**From:** Martina Gassner <[martina@escopacific.com.au](mailto:martina@escopacific.com.au)>  
**Sent:** Wednesday, 20 March 2019 2:43 PM  
**To:** Tim Stuckey <[Tim.Stuckey@planning.nsw.gov.au](mailto:Tim.Stuckey@planning.nsw.gov.au)>  
**Cc:** Rhiannon Olle <[Rhiannon@escopacific.com.au](mailto:Rhiannon@escopacific.com.au)>; Allison Hawke <[Allison@escopacific.com.au](mailto:Allison@escopacific.com.au)>  
**Subject:** RE: Wyalong Solar (SSD 9564) - More Information Required

**From:** Tim Stuckey <[Tim.Stuckey@planning.nsw.gov.au](mailto:Tim.Stuckey@planning.nsw.gov.au)>  
**Sent:** Monday, 18 March 2019 4:50 PM  
**To:** Martina Gassner <[martina@escopacific.com.au](mailto:martina@escopacific.com.au)>  
**Cc:** Iwan Davies <[iwan.davies@planning.nsw.gov.au](mailto:iwan.davies@planning.nsw.gov.au)>  
**Subject:** Wyalong Solar (SSD 9564) - More Information Required

**Re: Wyalong Solar Farm - Response to request for further information regarding noise assessment**

Project Layout - 130MW(DC)

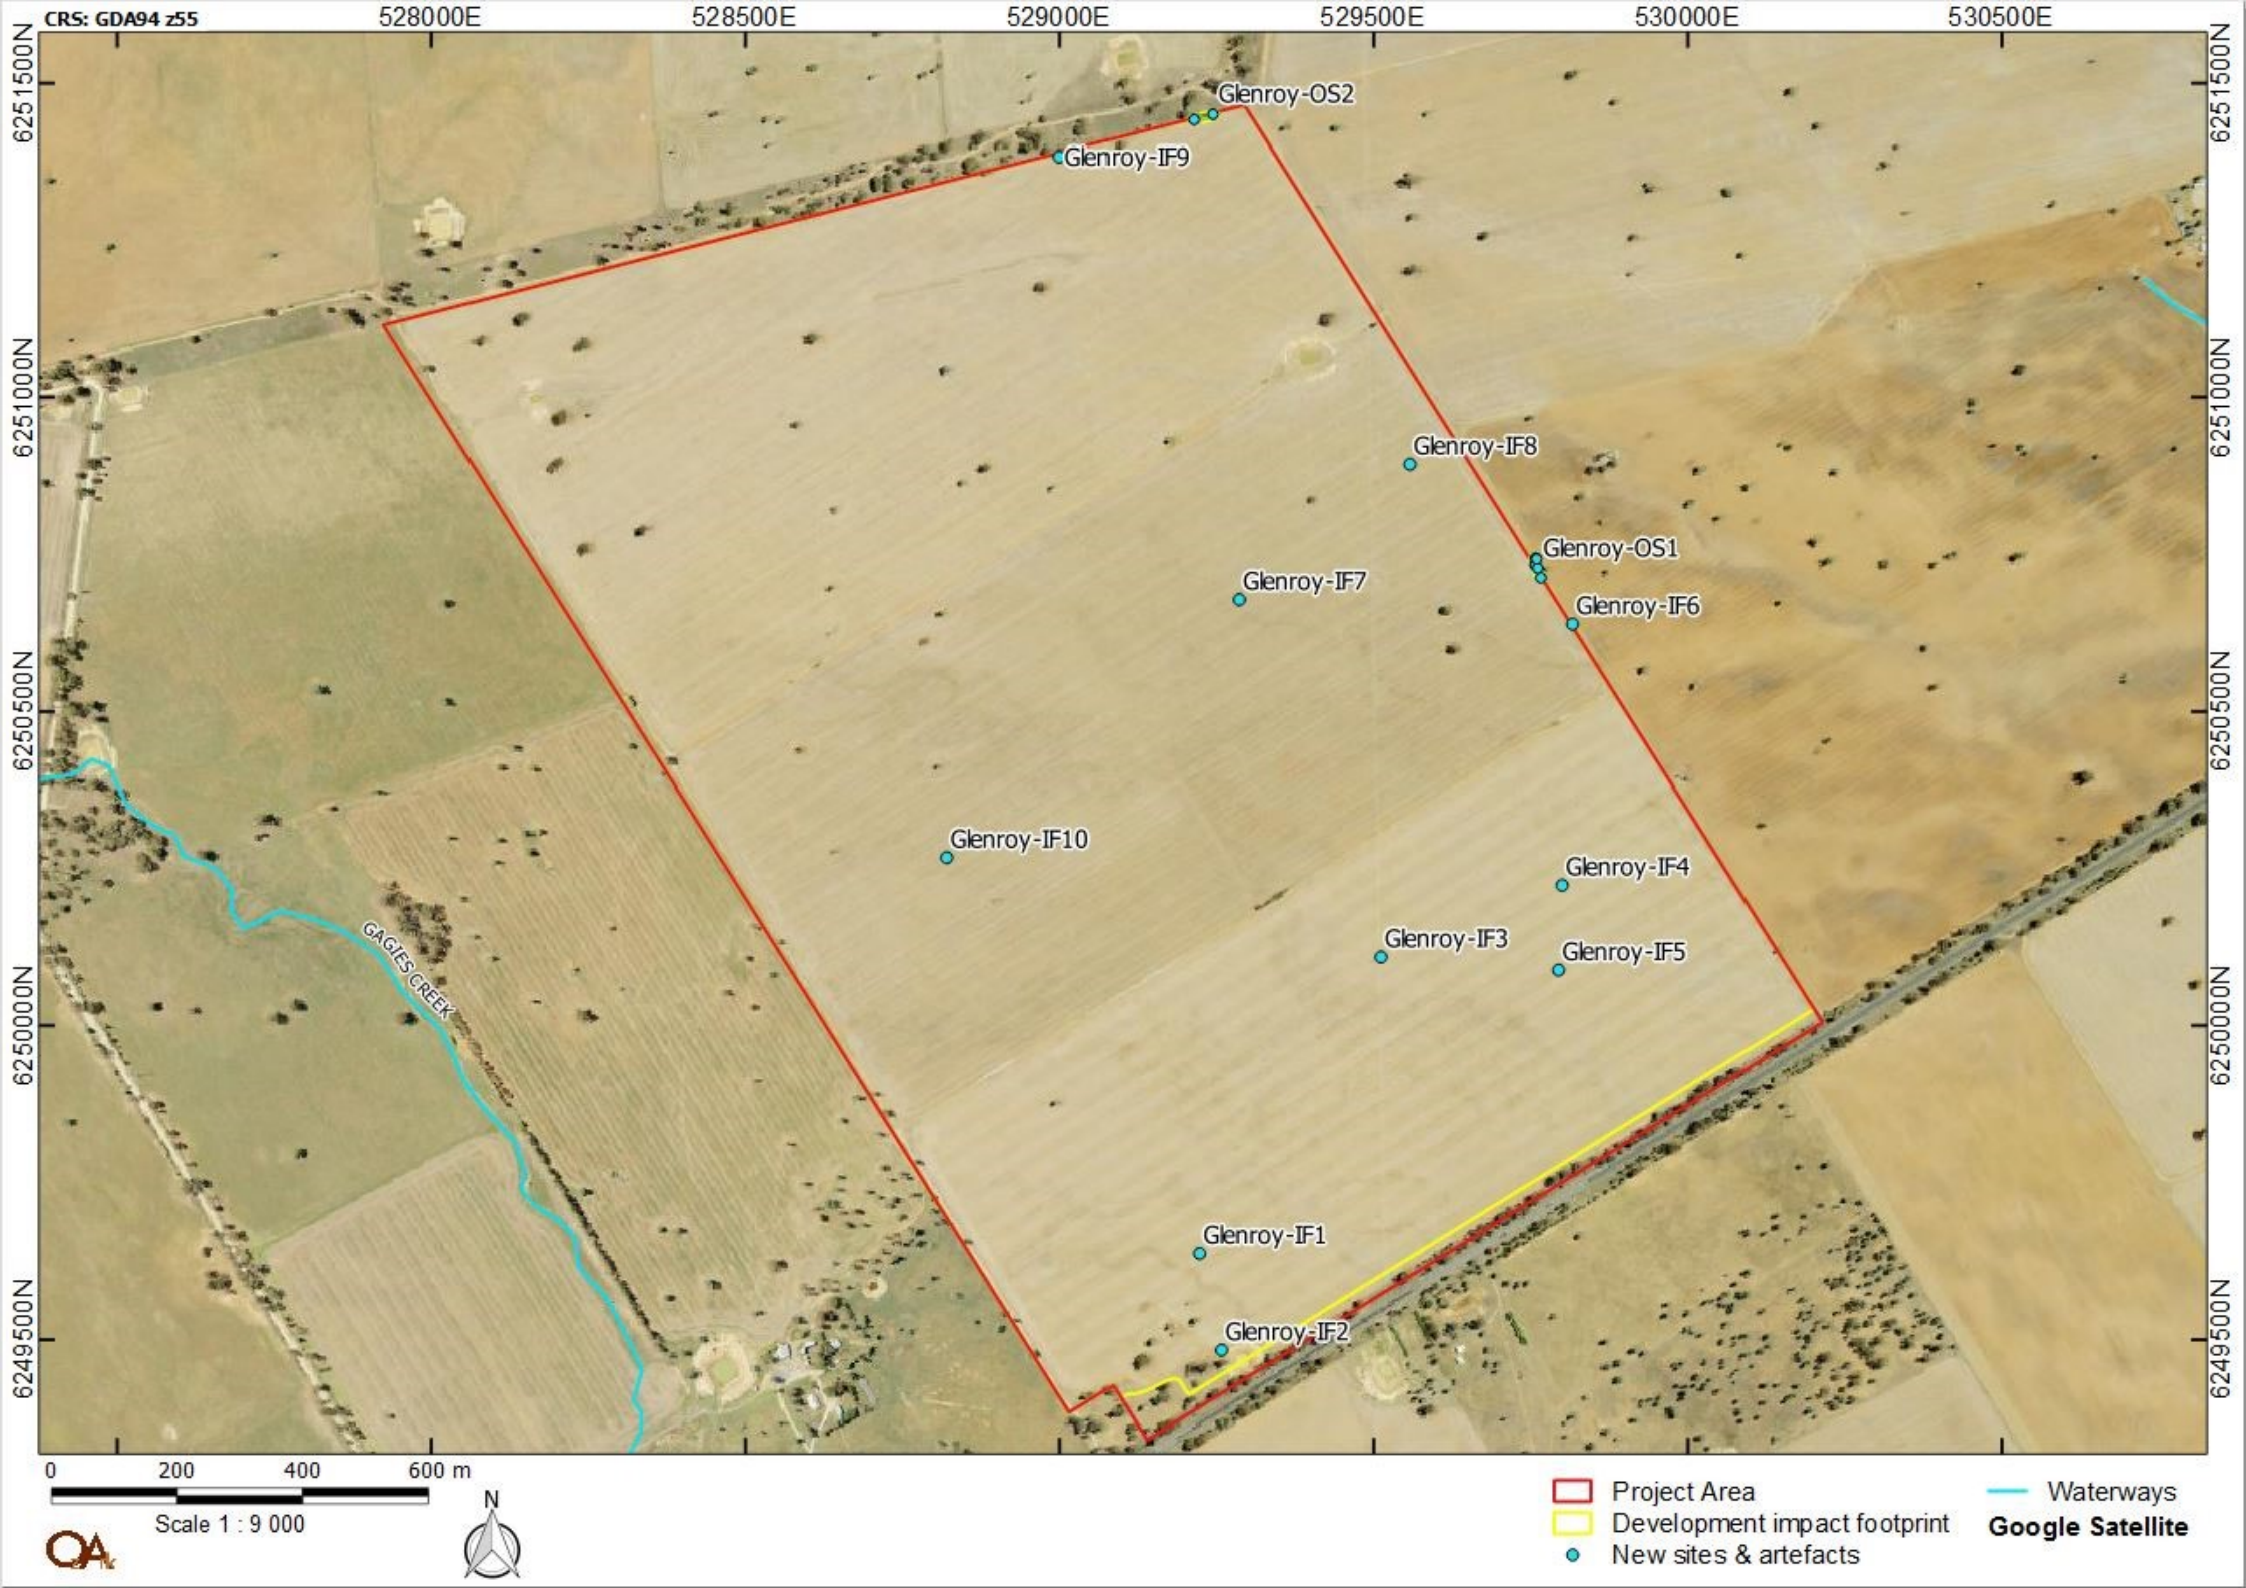
- visual impact – provide a revised landscaping and vegetation screening design, and confirm how this design will mitigate visual impacts to road users of the Newell Highway;

- mapping – revise Figure 3.1 (Project Layout) to comprise the following:
  - rename “Sensitive Receivers associated with the project” to *Associated Receiver*;

- rename “Sensitive Receivers” to *Non-associated Receiver*;
  - re-colour symbols for *Associated Receiver* and *Non-associated Receiver* to ensure they contrast against other symbols in the figure; and

- update figure to include vegetation screening design.

- visual impact – provide a revised landscaping and vegetation screening design, and confirm how this design will mitigate visual impacts to road users of the Newell Highway; **The Project Layout (Figure 3.1) has been revised to include the comments from DPE below. Supplementary screening has also been proposed along the southern boundary to mitigate the potential impacts (distraction/glare) for road users as raised by RMS and Bland Shire Council during the EIS Exhibition.**

- mapping – revise Figure 3.1 (Project Layout). **The Project Layout has been revised in line with DPE comments (please Wyalong Project Layout attached).**

**Figure 2.2**

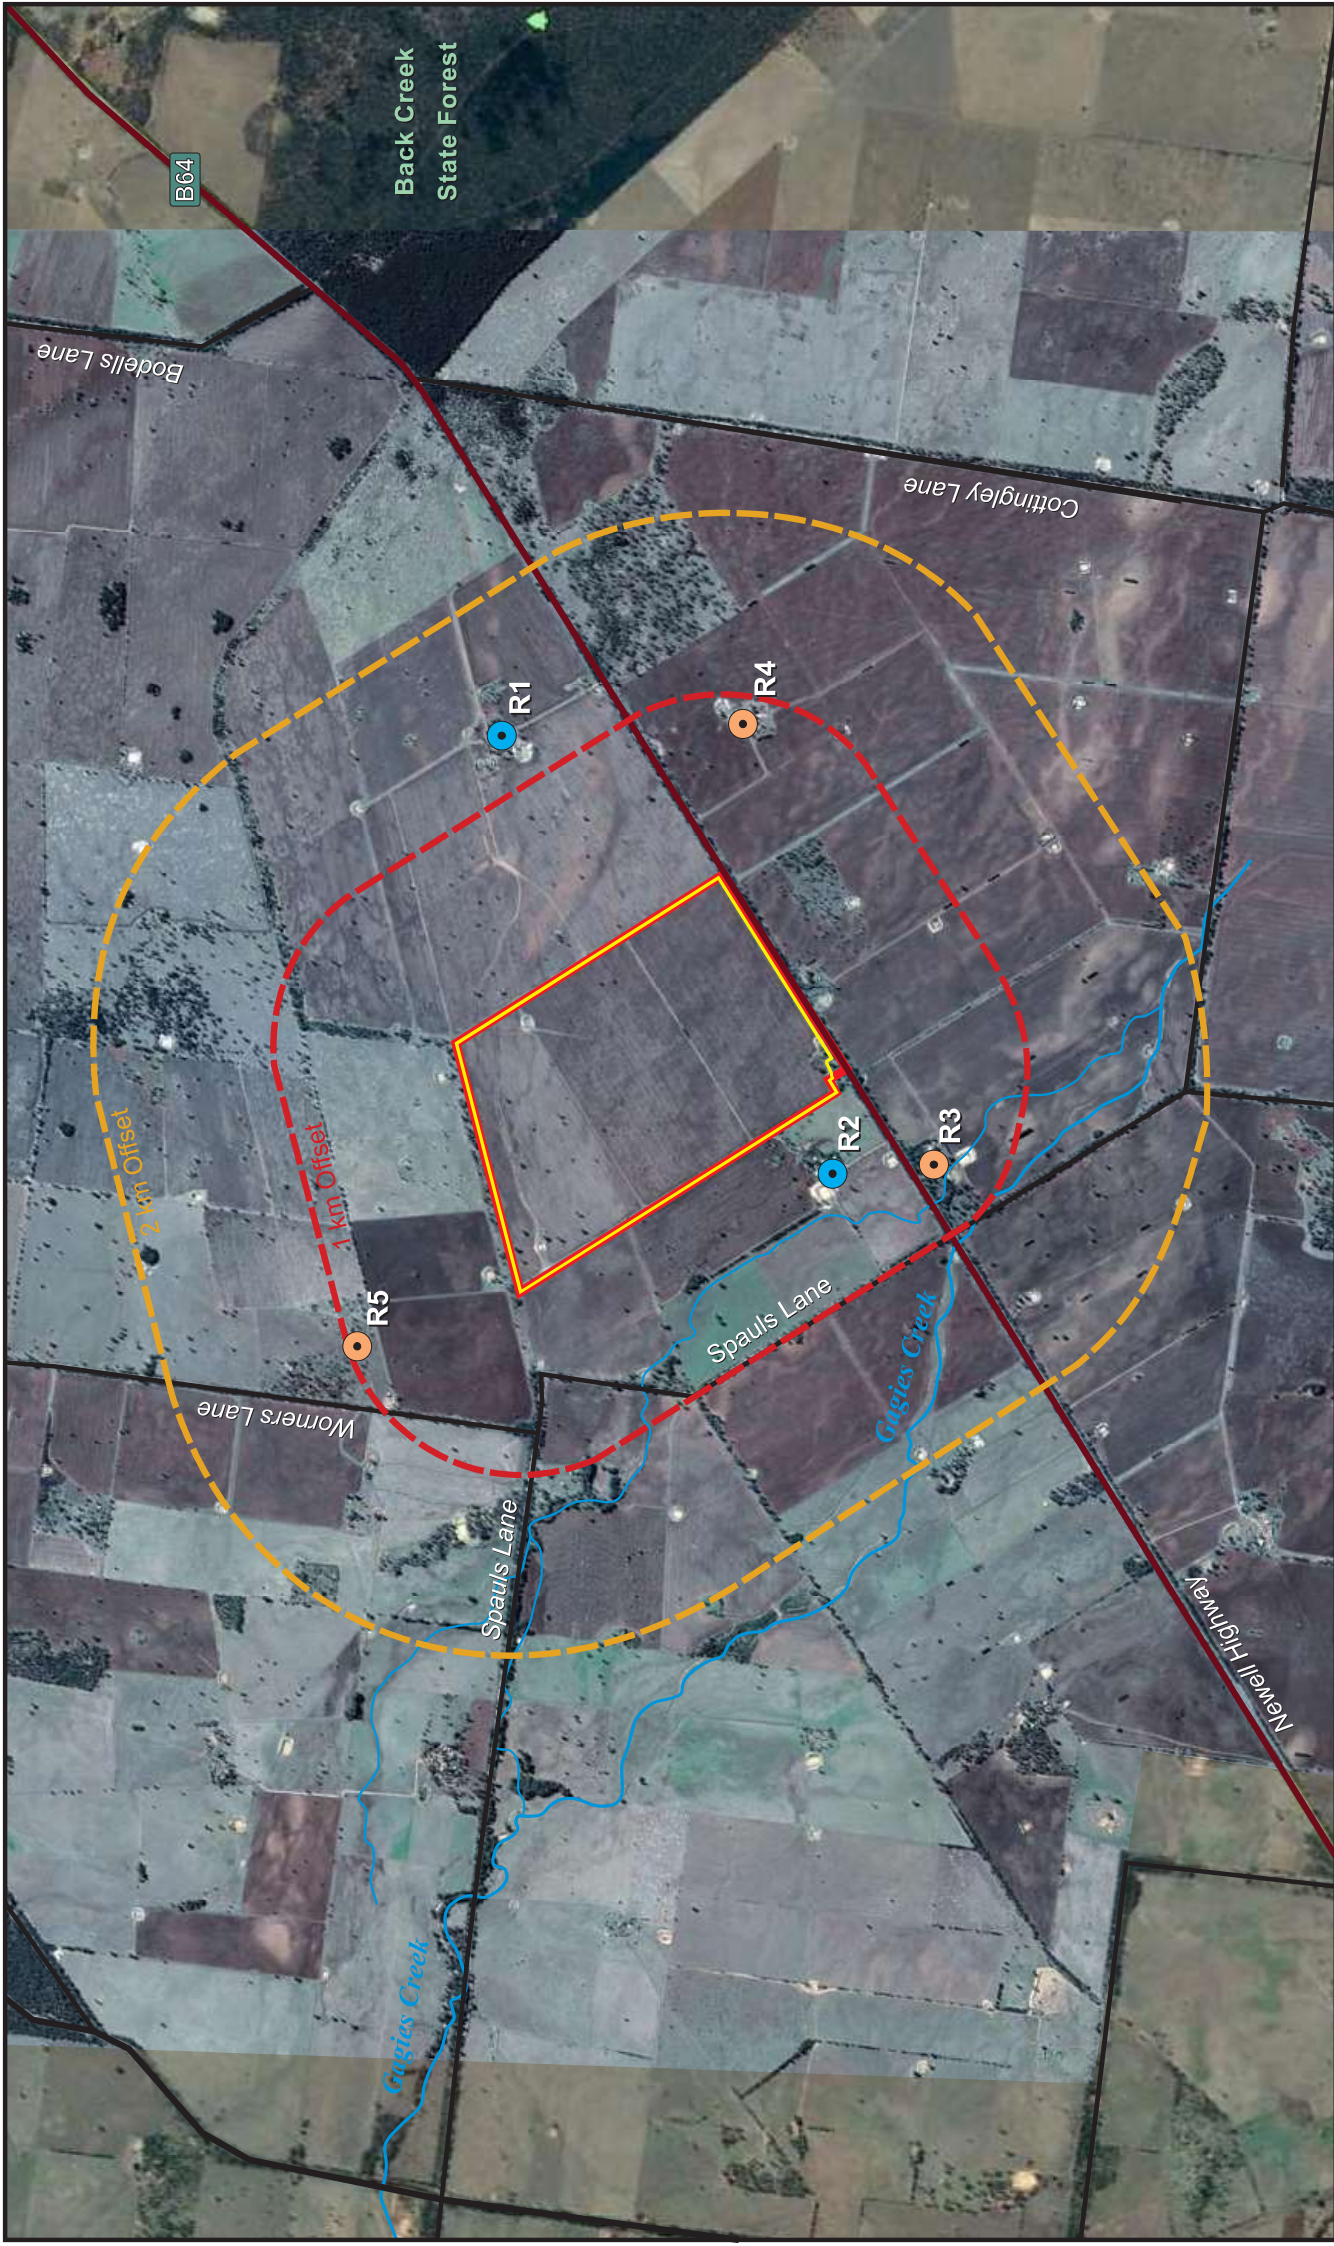
- *noise – confirm the maximum duration of noise exceedances experienced at R3, R4 and R5.*

- noise – confirm the maximum duration of noise exceedances experienced at R3, R4 and R5; **The noise assessment undertaken in the EIS has been refined and now shows a lower potential impact to the sensitive receivers than the worst case previously outlined (see Noise response and sensitive receivers figure). The occasional exceedance of the 45 dB(A) RBL may occur at the sensitive receiver R3 during the four months of earthworks. Exceedances are not anticipated at R4 and R5.**

- exposure to noise levels above the RBL of 45 dB(A) potentially occurs when activities are undertaken within 800 m of the sensitive receivers (note: R4 is 800 m & R5 is 1000 m from the project boundary)
- sensitive receiver R3 will potentially be exposed to noise levels above the RBL of 45 dB(A) during the two phases of earthworks.

Considering the percentage time of operation presented in Table 1, sensitive receiver R3 will potentially be exposed to noise levels above the RBL of 45 dB(A) during the earthworks phases for 40% of the time, but only when all plant is operating within 800 m of the sensitive receiver.

Although the earthwork phases of the project construction are expected to last for the first four months of the project, the area of the site that falls within 800 m of the residences occupies less than 2% of the overall project site. The potential for higher noise levels is reduced as construction moves away from the residences and exceedances are not expected for activities outside of this <2% area of the site.

In summary, if the assumptions regarding equipment use, construction phases and percentage times of operation area correct, then occasional exceedances of the 45 dB(A) RBL may occur at sensitive receiver R3 during the four months of earthworks. Exceedances are not anticipated at R4 and R5.
